**Town of Kittery  
Planning Board Meeting  
November 16 2023**

**ITEM 5—17 and 25 US Route 236—Major Site Plan — Preliminary Review**

**RE: Town of Kittery, Planning Board Services  
Major Site Plan Review – Preliminary Review  
Rooming House Redevelopment, 17 & 25 Route 236, Tax Map 20, Lot 12 and Tax Map 21, Lot 20  
CMA #591.165**

<b>TO:</b>	CMA Engineers- Jodie Bray Strickland, PE	<b>FROM:</b>	Geoffrey R. Aleva, PE	<b>DATE:</b>	11/2/2023
<b>SUBJECT:</b>	Major Site Plan Review – Preliminary Review				
<b>PROJECT:</b>	Rooming House Redevelopment, 17 & 25 Route 236, Tax Map 20, Lot 12 and Tax Map 21, Lot 20 C.C. Project # 2218000

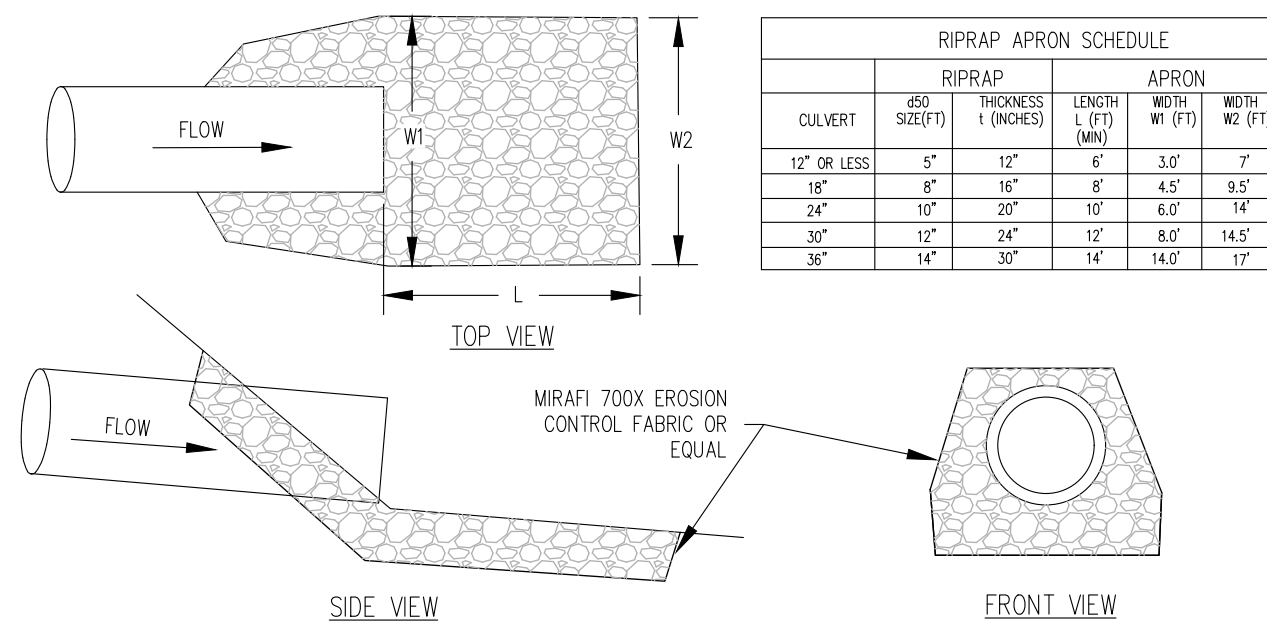
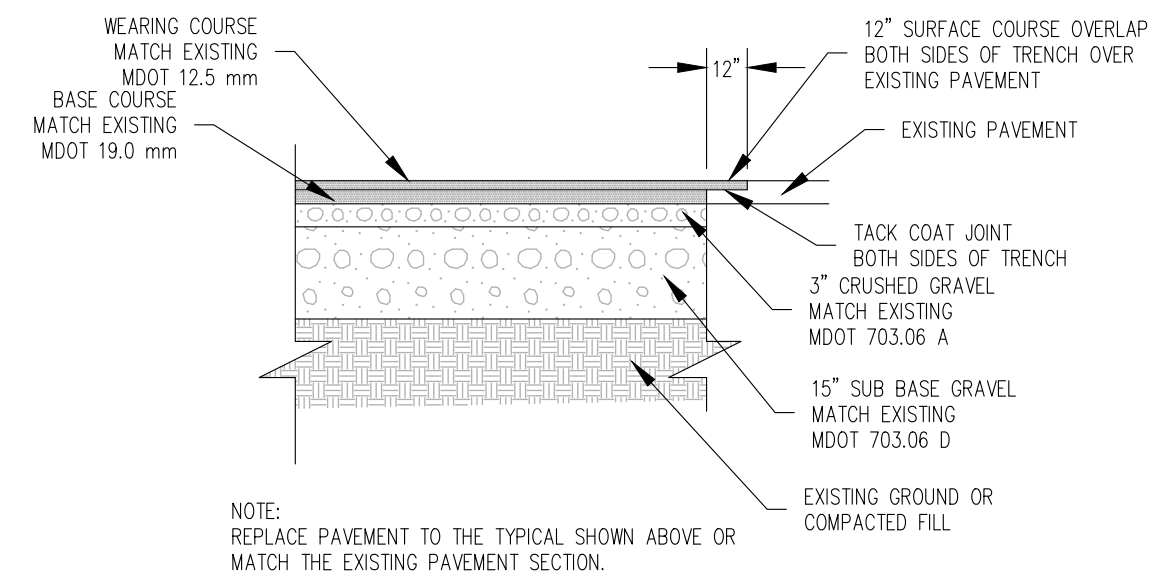
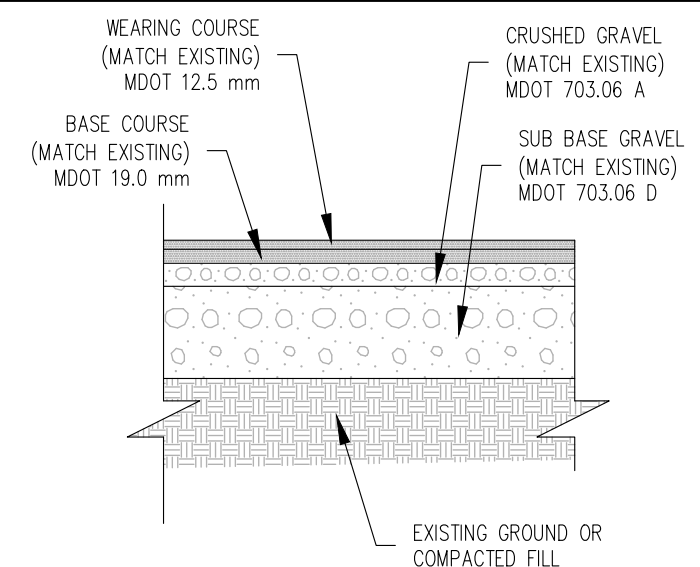
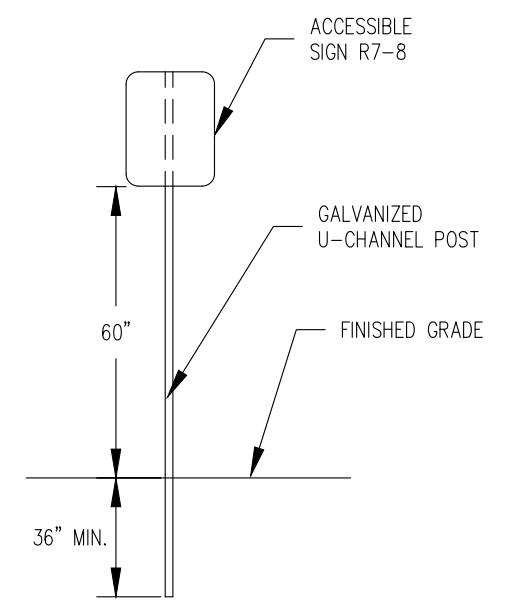
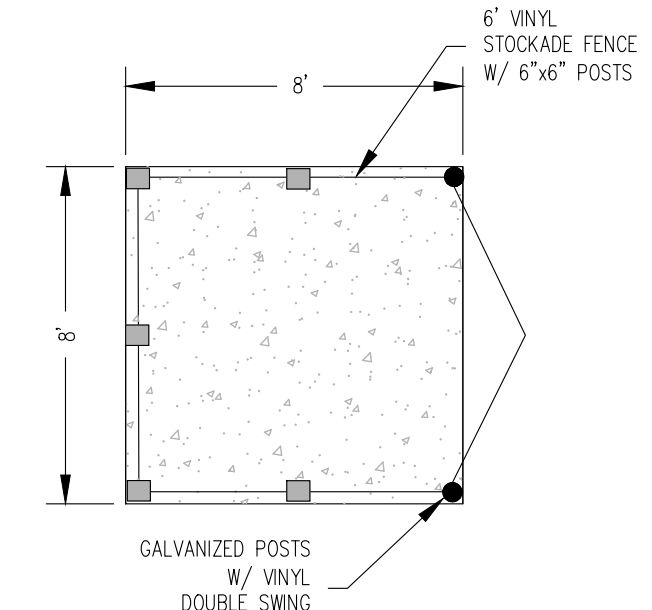
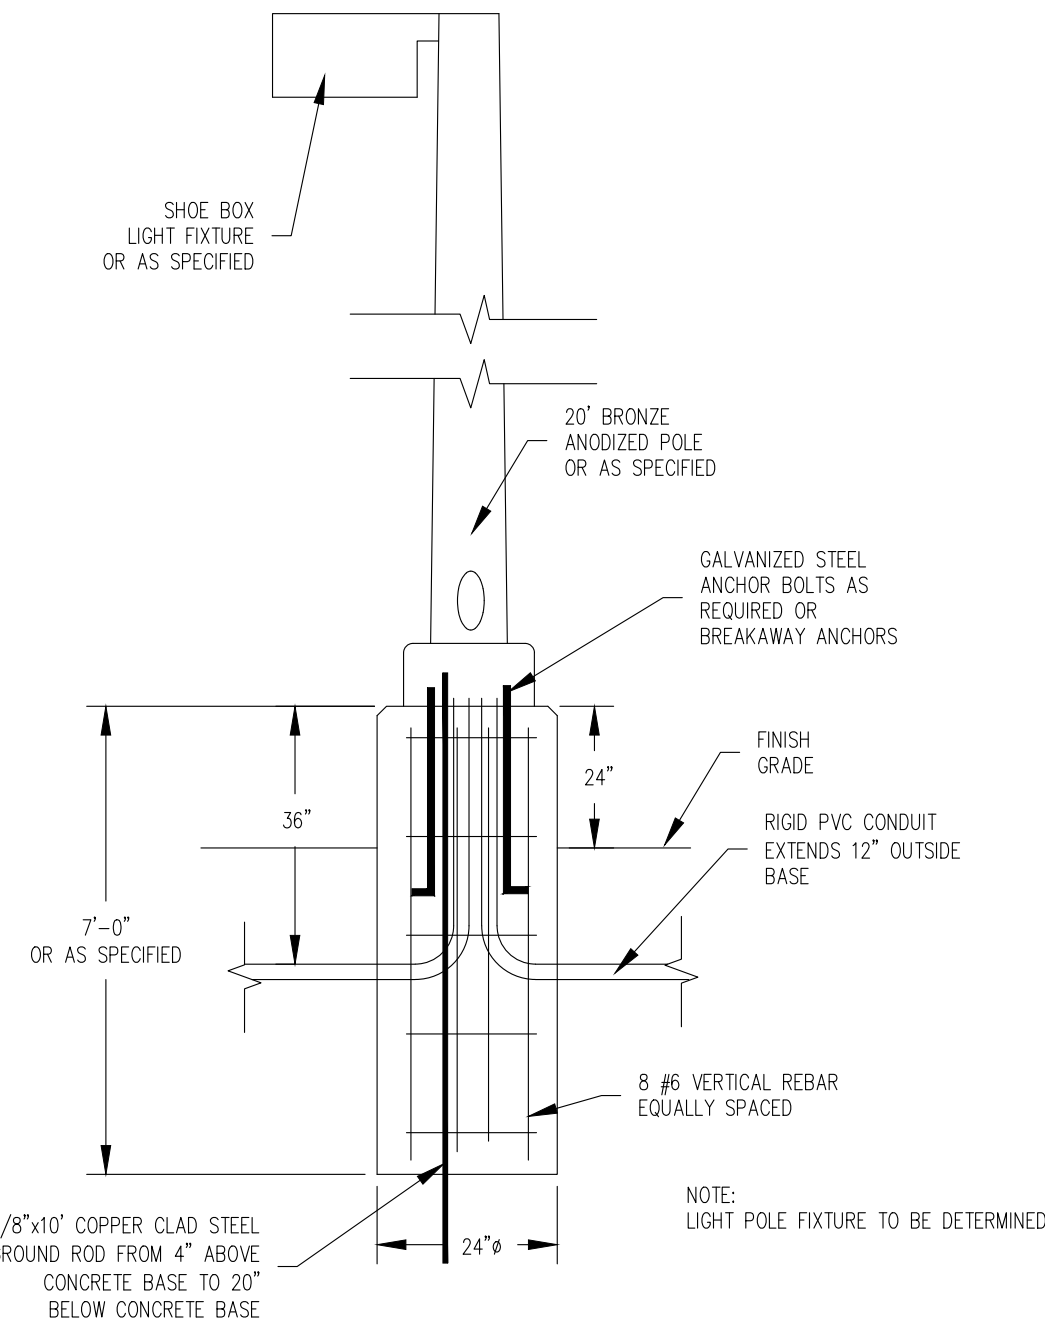
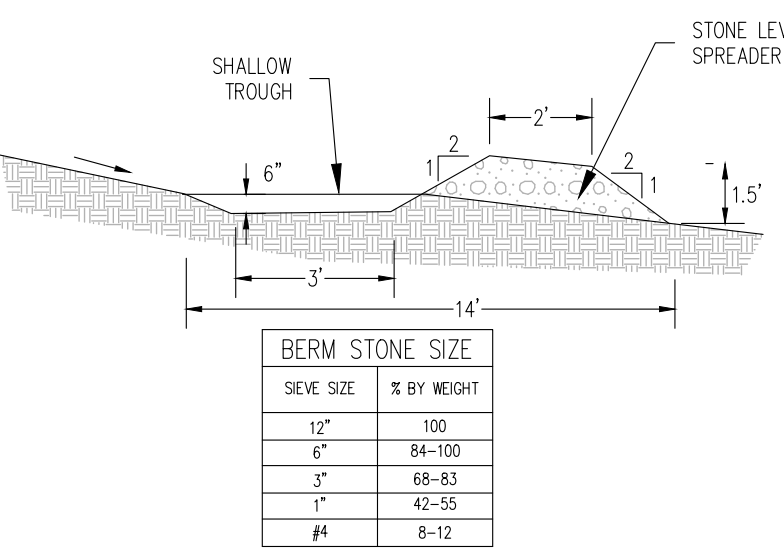
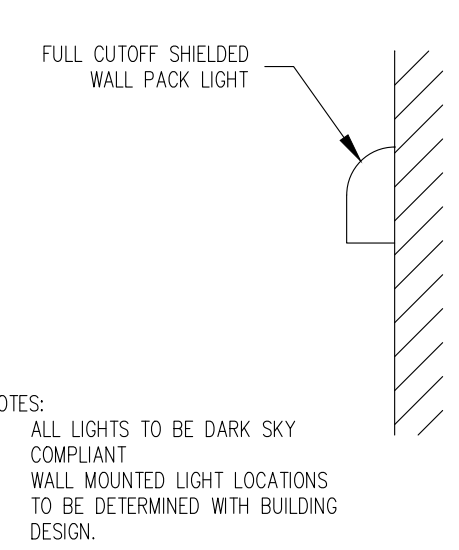
Sheet L2-Proposed Construction Details:

1. Where is the riprap apron(s) located? These should be called out on the plan.
2. Where is silt fence proposed to be used? Call this out on the plan.
3. More information and details are required on the proposed site lighting.

4. The Water Line Trench detail should show warning tape.
5. There should be a detail for the water service.
6. The Sewer/Drain line Trench with Insulation detail should show warning tape. Where is cover anticipated to be less than 5'? A sewer profile should be provided.

7. There should be a detail for the sewer service.
8. Where are the wall mount lights located?
9. There should be a detail for the pond.
10. The Roofline Drip edge Filter detail indicates there are foundation drains. These should be shown on the plan.

11. There should be a striping detail.
12. Details for the water main connection should be provided.
13. Provide details for thrust blocks.
14. Details for the sewer main connection should be provided.

15. There should be a trench patch detail for the work in Route 236.
16. The Typical Pavement Section should specify pavement and gravel thicknesses (not match existing). The details should include tackifier and/or lane joint adhesive.

<b>Sheet L2-Proposed Construction Details:</b>	
<ol style="list-style-type: none"> <li>1. Where is the riprap apron(s) located? These should be called out on the plan.</li> <li>2. Where is silt fence proposed to be used? Call this out on the plan.</li> <li>3. More information and details are required on the proposed site lighting.</li> </ol>	<ol style="list-style-type: none"> <li>1. <i>Riprap aprons have been indicated.</i></li> <li>2. <i>Silt fence detail has been removed, erosion control mulch berm is proposed.</i></li> </ol>

<ol style="list-style-type: none"> <li>4. The Water Line Trench detail should show warning tape.</li> <li>5. There should be a detail for the water service.</li> <li>6. The Sewer/Drain line Trench with Insulation detail should show warning tape. Where is cover anticipated to be less than 5'? A sewer profile should be provided.</li> <li>7. There should be a detail for the sewer service.</li> <li>8. Where are the wall mount lights located?</li> <li>9. There should be a detail for the pond.</li> <li>10. The Roofline Drip edge Filter detail indicates there are foundation drains. These should be shown on the plan.</li> <li>11. There should be a striping detail.</li> <li>12. Details for the water main connection should be provided.</li> <li>13. Provide details for thrust blocks.</li> <li>14. Details for the sewer main connection should be provided.</li> <li>15. There should be a trench patch detail for the work in Route 236.</li> <li>16. The Typical Pavement Section should specify pavement and gravel thicknesses (not match existing). The details should include tackifier and/or lane joint adhesive.</li> </ol>	<ol style="list-style-type: none"> <li>3. <i>Site lighting requirements are to be determined. See above comment for more information. We will provide a lighting plan in the next submission.</i></li> <li>4. <i>Warning tape has been indicated.</i></li> <li>5. <i>Water service detail has been added.</i></li> <li>6. <i>Sewer and drain line warning tape has been added.</i></li> <li>7. <i>Sewer service detail has been added.</i></li> <li>8. <i>Wall mount light will be determined when the building design is completed.</i></li> <li>9. <i>Storm pond outlet inverts are indicated.</i></li> <li>10. <i>Foundation drains have been added to plans.</i></li> <li>11. <i>Striping dimensions are shown on the plans.</i></li> <li>12. <i>Water connection details have been added.</i></li> <li>13. <i>Thrust block detail has been added.</i></li> <li>14. <i>Sewer manhole has been added for connection from force main.</i></li> <li>15. <i>Trench patch detail has been added to plans.</i></li> <li>16. <i>A pavement replacement detail has been added. New pavement section is for parking area.</i></li> </ol>

**EXISTING CONDITIONS SITE PLAN**

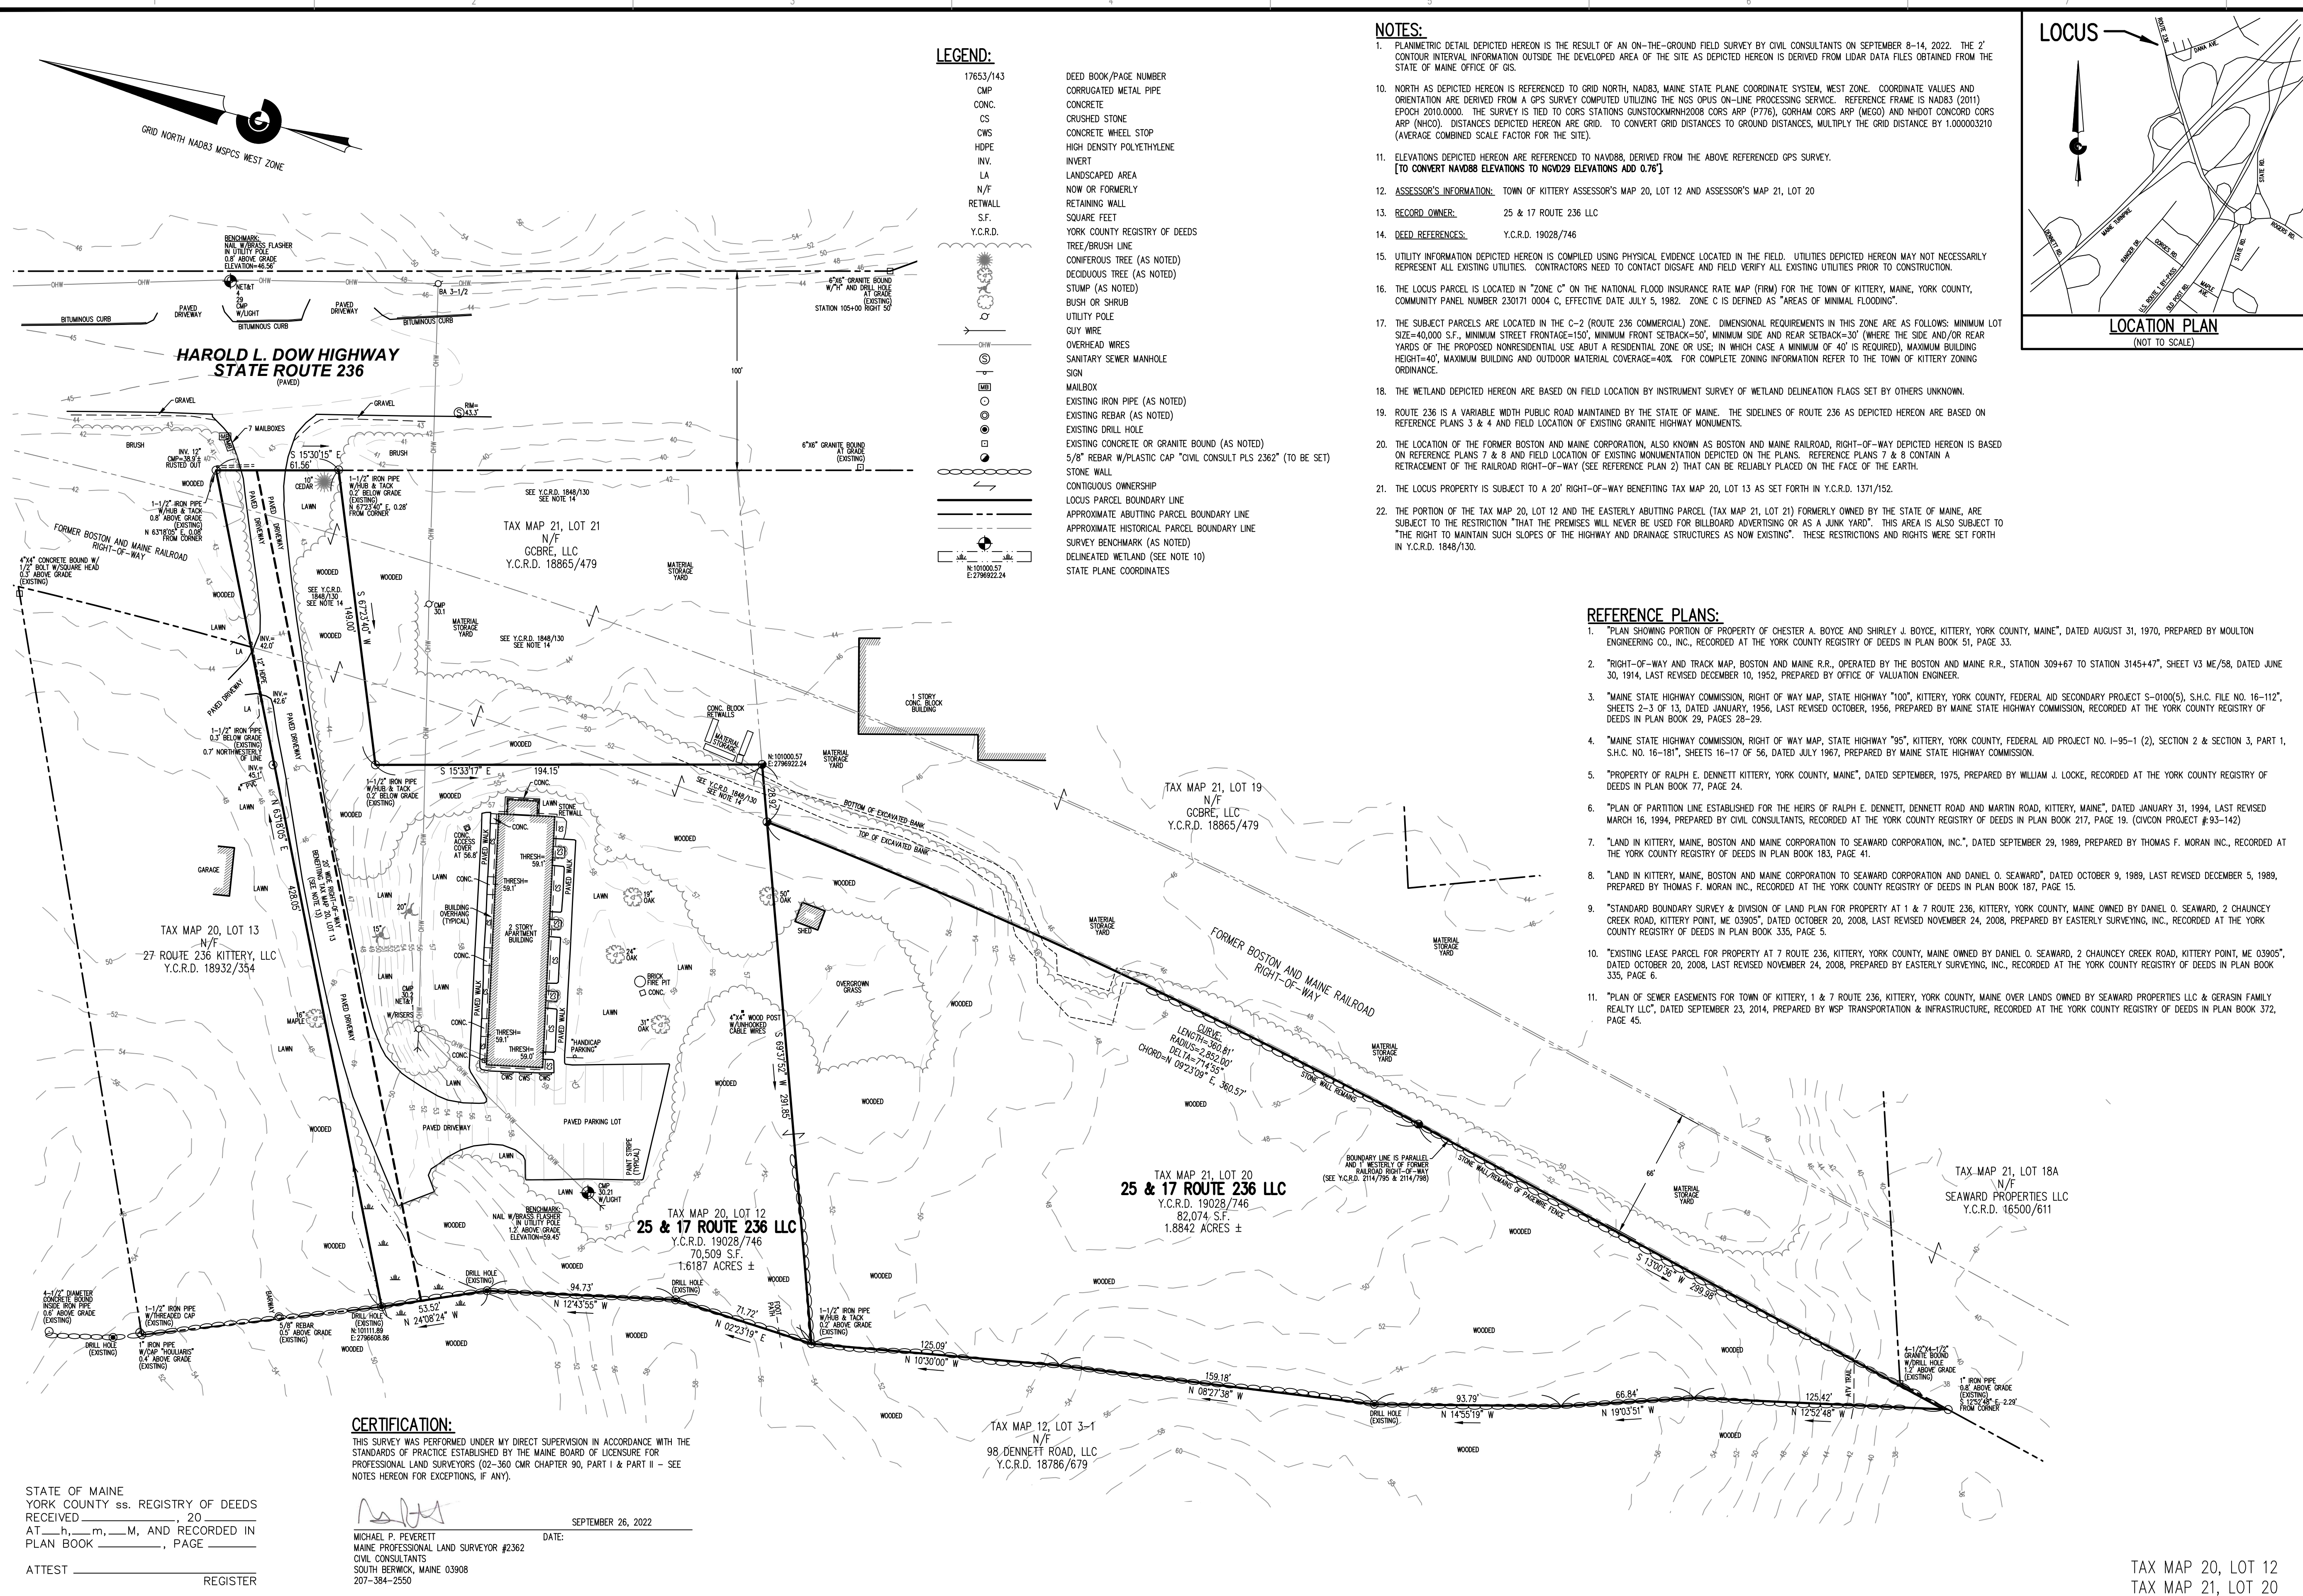
Sheet EC1-Boundary/Existing Conditions Plan:

1. Existing utilities – sizes, materials, inverts, etc. should be shown on the plan.

<b>Sheet L3-Maintenance Notes:</b>	
<ol style="list-style-type: none"> <li>1. The Maintenance Procedures should be updated to apply to this project.</li> </ol>	<ol style="list-style-type: none"> <li>1. <i>The maintenance notes have been updated</i></li> </ol>
<b>Sheet EC1-Boundary/Existing Conditions Plan:</b>	
<ol style="list-style-type: none"> <li>1. Existing utilities – sizes, materials, inverts, etc. should be shown on the plan.</li> </ol>	<ol style="list-style-type: none"> <li>1. <i>Existing utility sizes have been indicated on the site plan. The ECI plan does not indicate underground utilities.</i></li> </ol> <p style="text-align: center;"><i>The existing sewer information shown on L1 is based on information provided by the Kittery Sewer Department. We have added an additional sheet to indicate the known utilities, See Sheet ECSP.</i></p>
